Design Review Report – Item 1

Local government:	City of Stirling	
Item no.:	Item 1 – DA23/0802 – 92 Princess Road, Balga – Development Assessment Panel – Form 1 – Child Care Premise	
Chairperson:	Emma Williamson	
Panel members:	Anthony Duckworth Peter Damen Jackson Liew	
Local government officers:	Dean Williams Karina Bowater Simone Palmer Kelly Douglas	Acting Coordinator Planning Senior Planning Officer DRP Support Officer Client Liaison Officer
Observers		
Date:	2 November 2023	Time: 2pm
Venue:	City of Stirling – Challenger Room

Recommendations Summary
Item 1 – DA23/0802 - 92 Princess Road, Balga

PLANTING PLAN

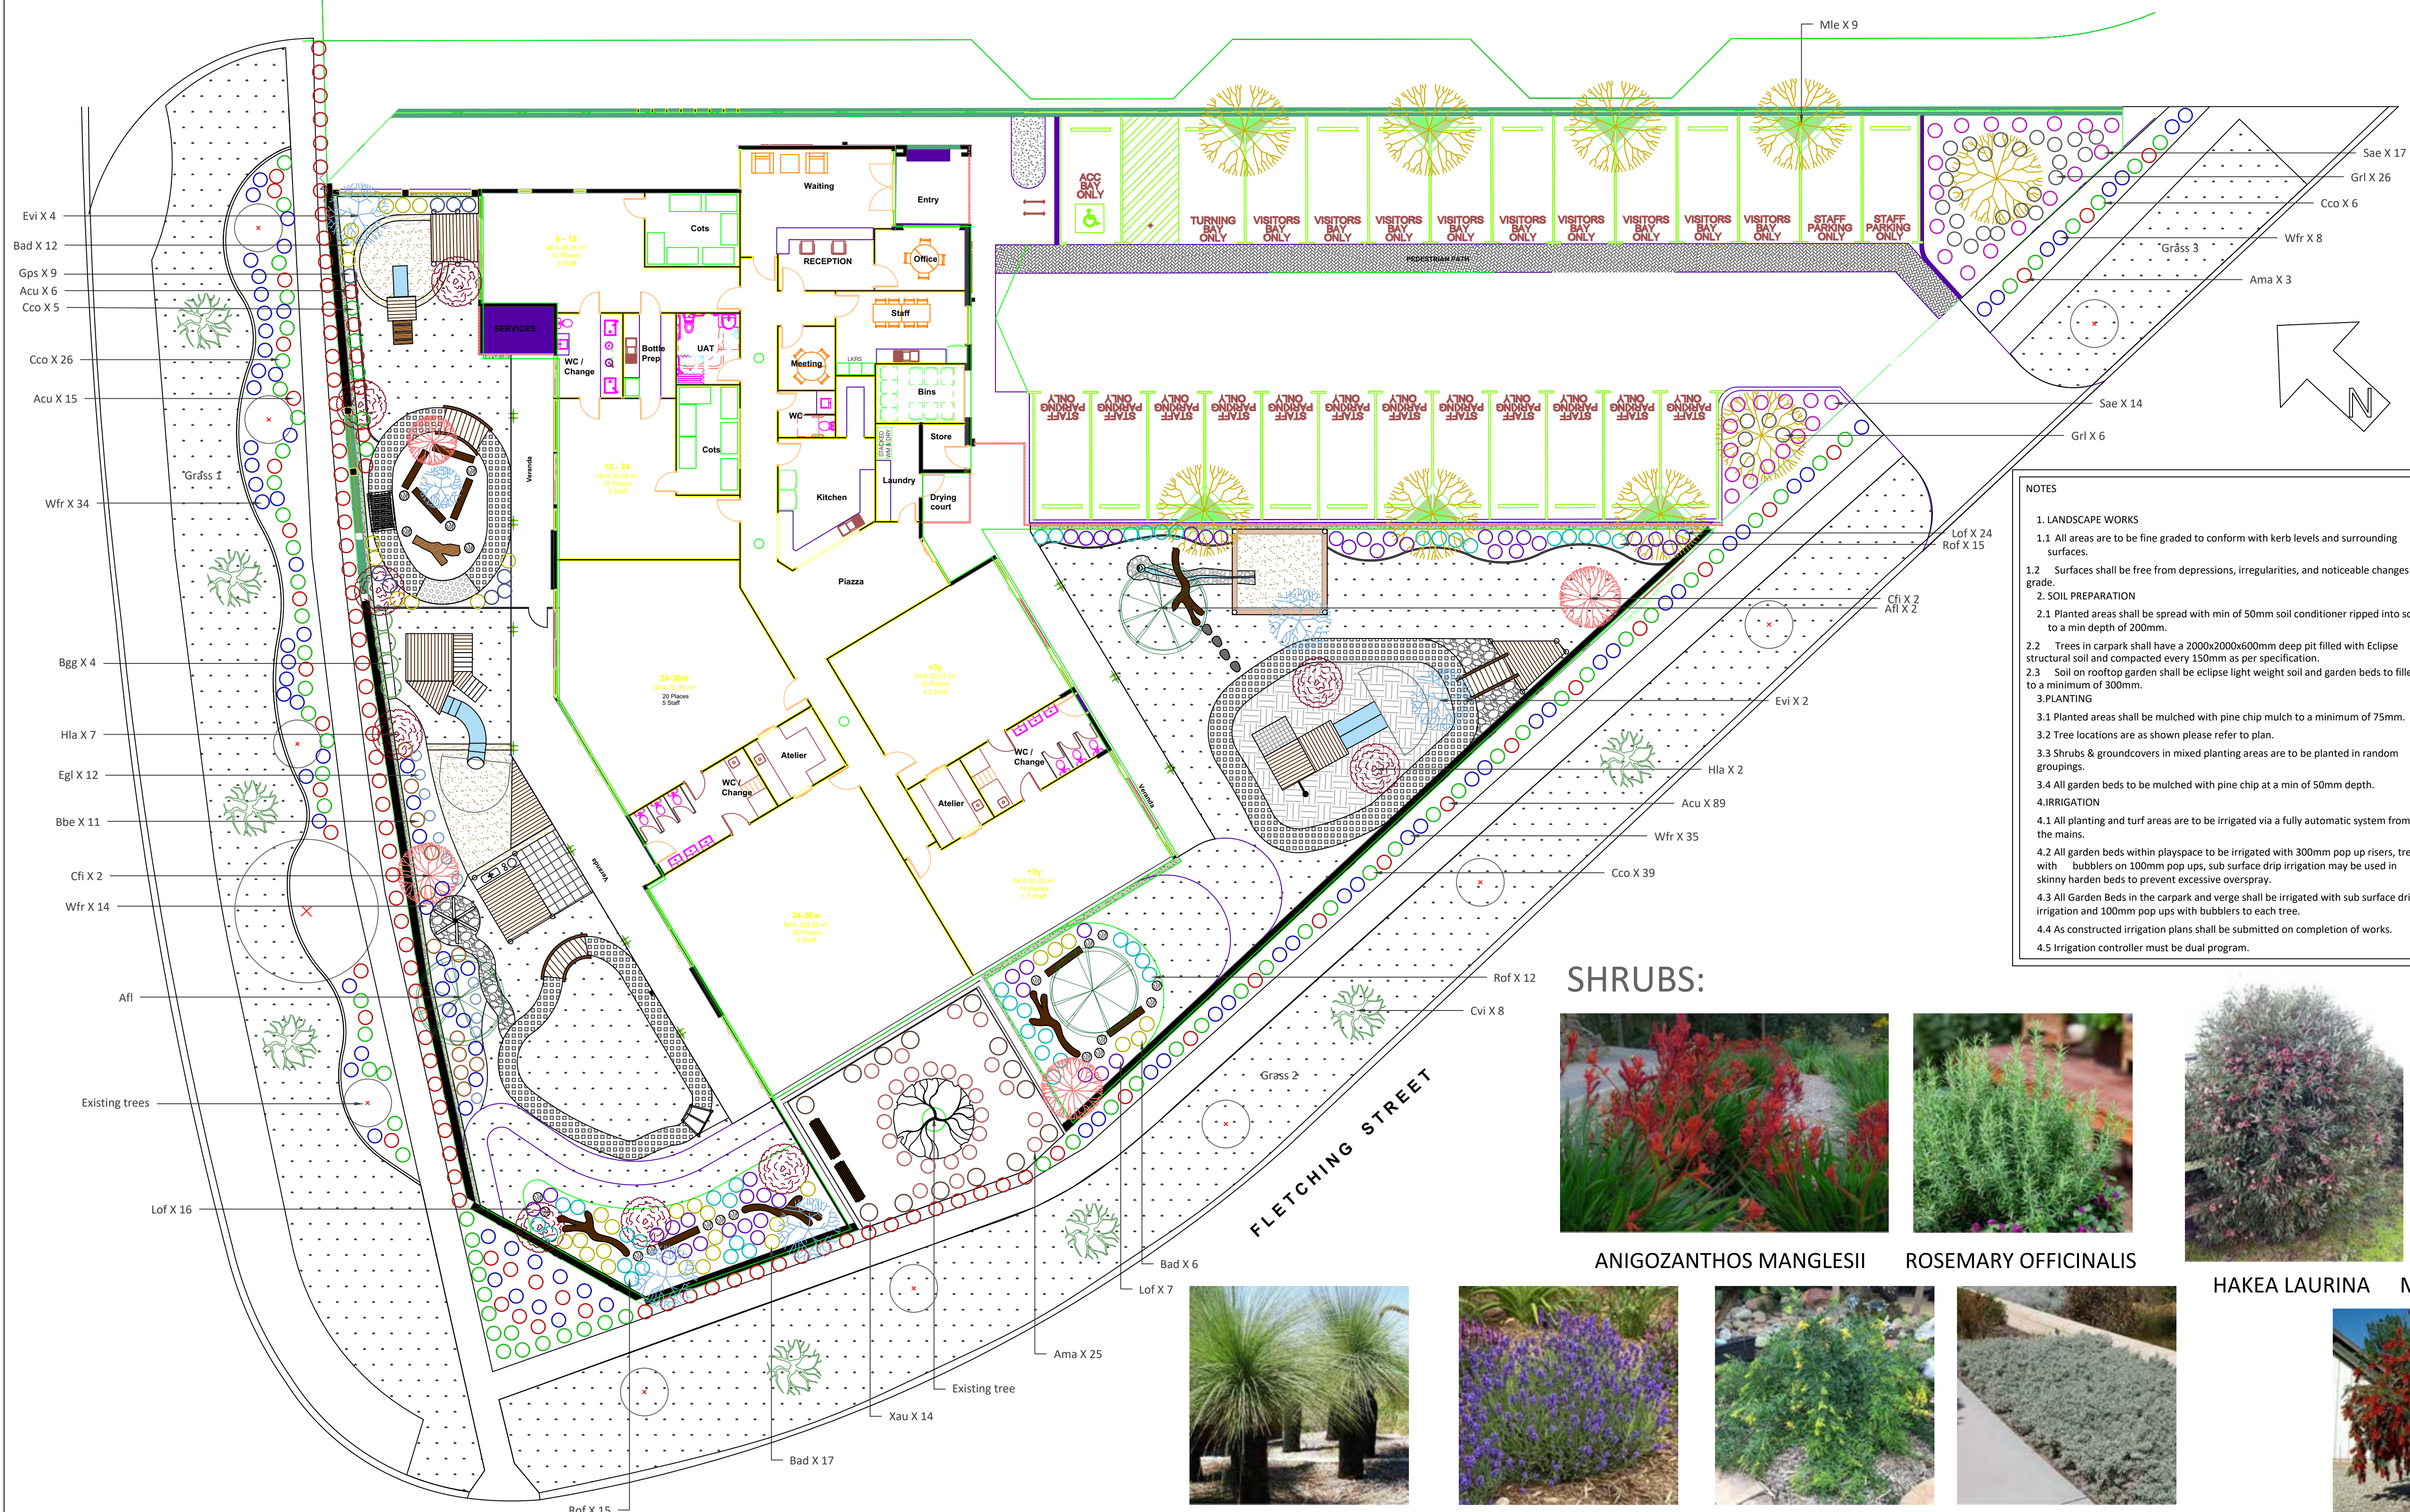
Principle 2 Landscape quality	<i>Good design recognises that together landscape and buildings operate as an integrated and sustainable system, within a broader ecological context.</i>
	2a. The Panel support the retention of the large Jarrah tree on site. The Panel recognize the challenge that this creates due to the changes in levels across the site. The Panel understand the approach by the Applicant to fence around the tree, making this area publicly accessible and expressed concern in relation to the potential for this to become neglected. The Panel request further clarification in relation to the maintenance, amenity and safety of this area. 2b. The Panel commented on the opportunity and need to include additional trees on the site. Increasing the extent of trees in the carpark is one obvious area where the landscape can be used to enhance the proposal and reduce the urban heat island effect. Additionally, trees could be incorporated into the play spaces, creating meaningful shade for children. 2c. The Panel commented on the need for an integrated landscape and architecture response to shade across the scheme noting that the “tin roof” nominated over the sandpit was not considered a good quality outcome. Elements within the landscape spaces, particularly shade structures require architectural resolution. 2d. Comment was made by the Panel the northern connection of the pedestrian access path to the footpath on Princess Road requires resolution and integration as the current landscape proposal prevents this connection.

2a. The Panel do not support the removal of the large Jarrah tree on site and request an arborist report to establish the viability of the tree. The suburb of Balga has a critically low tree canopy (less than 6%) and every effort needs to be made to prevent further diminution. 2b. Comment was made by the Panel clarity around the calculations and usability of the outdoor spaces is required, noting that some of the west-facing areas appear too small to be practical. It is important to ensure outdoor spaces can be safely used by the occupants and the design of these areas should be integrated into the plans. 2c. The Panel commented on the	2a. Jarrah tree retained with significant area remaining undisturbed for root ball, which an arborist is to advise on this. 2b. Outdoor spaces have been designed, refer to Landscape Design, with approx. 40m2 area additional area provided. 2c. Additional trees included. 2d. Slopes areas have been incorporated to create dynamic play spaces. 2e. Recycled asphalt paving is proposed. Soak wells will permeate stormwater equally effectively as permeable paving. 2f. A pedestrian accessway has been provided along the northern façade with additional	2a. The Panel support the retention of the large Jarrah tree on site. The Panel recognize the challenge that this creates due to the changes in levels across the site. The Panel understand the approach by the Applicant to fence around the tree, making this area publicly accessible and expressed concern in relation to the potential for this to become neglected. The Panel request further clarification in relation to the maintenance, amenity and safety of this area. 2b. The Panel commented on the opportunity and need to include additional trees on the site. Increasing the extent of trees in

opportunity and need to include additional trees on site. Increasing the extent of trees in the carpark is one obvious area for this. 2e. The Panel commented on the opportunity to further develop the design of the retaining wall within the play spaces to make this an interesting and dynamic element. 2f. It was suggested by the Panel to consider permeable paving in the carpark area. 2j. Comment was made by the Panel the external pathway on the northern edge of the building is narrow and it's purpose is unclear. The Panel queried the need for fencing here and whether the opportunity exists to landscape this area to the street.	entrance door included.	the carpark is one obvious area where the landscape can be used to enhance the proposal and reduce the urban heat island effect. Additionally, trees could be incorporated into the play spaces, creating meaningful shade for children. 2c. The Panel commented on the need for an integrated landscape and architecture response to shade across the scheme noting that the "tin roof" nominated over the sandpit was not considered a good quality outcome. Elements within the landscape spaces, particularly shade structures require architectural resolution.
